Access Compliance Report

Intersection ID: 12562	Main Street: PENCE_GROVE_RD	Cross Street: SILVER_CHARM_CT	Location: S
ADA ID: DECAEDF162A2	Ramp Type: Perp	Initial Pass/Fail: Fail	Overall Compliance: No
Severity Score: 8.75			
Codes/Mitigation Info/Possible Solution		Field Measurements/Component Compliance

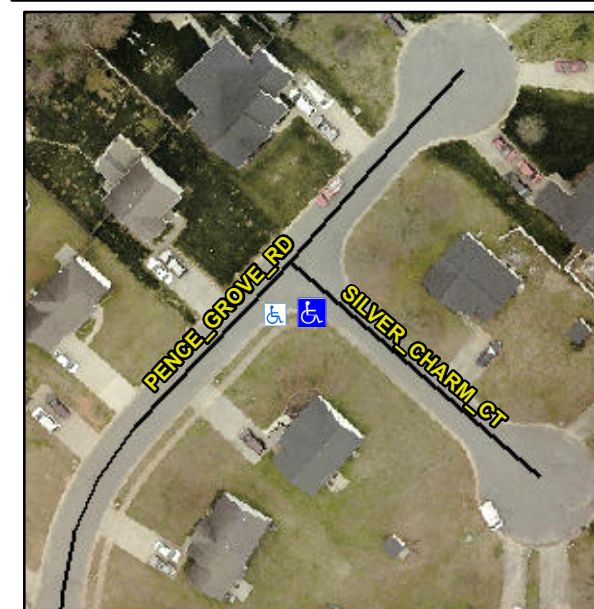
Not Found, R304.5.1

Compliance	Description	Data	Compliance	Description	Data
N/A	Ramp Length (in)	44.5	Yes	Ramp Slope (%)	6.8
No	Ramp Width (in)	42.0	Yes	Ramp XSlope (%)	1.2
N/A	Flare Type LT	N/A	N/A	Flare Type RT	N/A
N/A	Flare Slope LT (%)	N/A	N/A	Flare Slope RT (%)	N/A
N/A	Flare Traversable LT?	N/A	N/A	Flare Traversable RT?	N/A
N/A	Landing Length (in)	N/A	N/A	DWS Provided?	N/A
N/A	Landing Width (in)	N/A	N/A	DWS Contrast?	N/A
N/A	Landing Slope (%)	N/A	N/A	DWS Length (in)	N/A
N/A	Landing X Slope (%)	N/A	N/A	DWS Full Width?	N/A
N/A	Landing Curb? (Y/N)	N/A	N/A	DWS Offset (in)	N/A
N/A	Shared Landing?	N/A			
N/A	Gutter Ponding?	N/A	N/A	Gutter Slope (%)	N/A
N/A	Gutter Lip Ht (in)	N/A	N/A	Gutter X Slope (%)	N/A
N/A	Painted X Walk1?	No	N/A	Painted X Walk2?	N/A
	X Walk 1 Direction	To NE		X Walk 2 Direction	N/A
N/A	X Walk 1 Width (in)	N/A	N/A	X Walk 2 Width (in)	N/A
	X Walk 1 Slope (%)	0.7		X Walk 2 Slope (%)	N/A
	X Walk 1 X Slope (%)	1.1		X Walk 2 X Slope (%)	N/A

Remove & Replace Entire Ramp.
